## Landscape Referral Response

<b>Application Number:</b>	DA2020/1163
<b>Date:</b>	27/11/2020
<b>Responsible Officer:</b>	Megan Surtees
<b>Land to be developed (Address):</b>	Lot 102 DP 13760 , 24 Wandeen Road CLAREVILLE NSW 2107

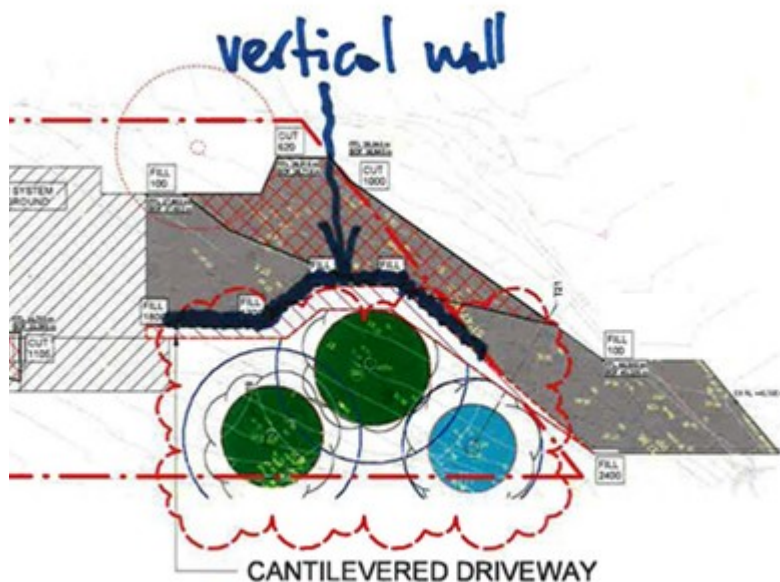
Existing ground levels within the tree protection zone of existing trees T19 - Spotted Gum, T20 - Spotted Gum, T21 - Spotted Gum shall remain unaltered, and the proposed driveway as amended shall include a vertical wall at the alignment of the cantilevered driveway section, as demonstrated below to ensure the protection of the existing trees:

The vertical wall at the edge of the cantilevered driveway is to be constructed prior to establishment of the site access ramp, effectively restricting access to the majority of tree protection zones of T19, T20 and T21, and tree protection fencing to be placed along the alignment of the cantilevered driveway. All existing ground levels within the tree protection fencing shall remain unaltered.

- i) document the alignment of the vertical wall at the edge of the cantilevered driveway,
- ii) all Plans shall document the retention of existing ground levels within the tree protection zones for existing trees T4 - Bangalay, T19 - Spotted Gum, T20 - Spotted Gum, and T21 - Spotted Gum,
- iii) all Plans shall document tree protection fencing around the tree protection zones for existing trees T4 - Bangalay, T19 - Spotted Gum, T20 - Spotted Gum, and T21 - Spotted Gum.
